PLANNER'S SECTION 42A REPORT FOR

PLAN CHANGE 52: MOUNT CARDRONA STATION SPECIAL ZONE

REPORT DATED: 16 June 2017

SUBMITTED BY: Nigel Bryce
Consultant Planner

Figure 1 – Proposed Structure Plan Amended by proposed Plan Change 52 (with Golf Course identified within Activity Area 9)

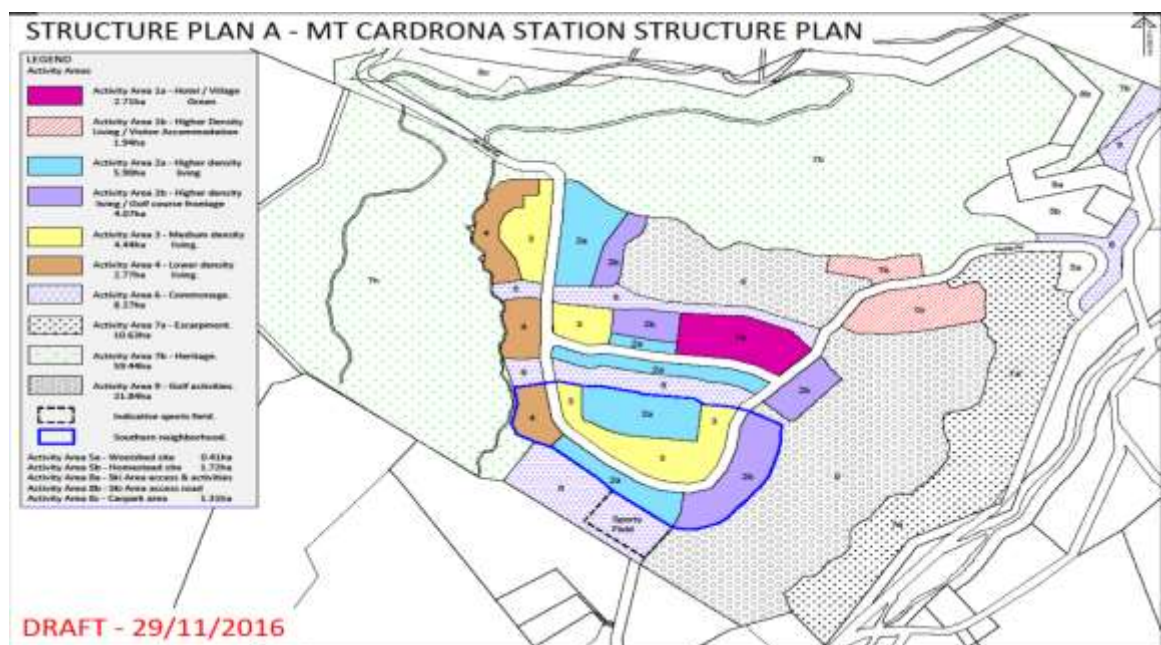
One of the most significant changes introduced by the Plan Change is that it proposes to expand proposed Activity Area 4 to the west to (in part) compensate for residential development area lost by the inclusion of the golf course. The extent of this change is clearly shown in Figures 2 and 3 overleaf.
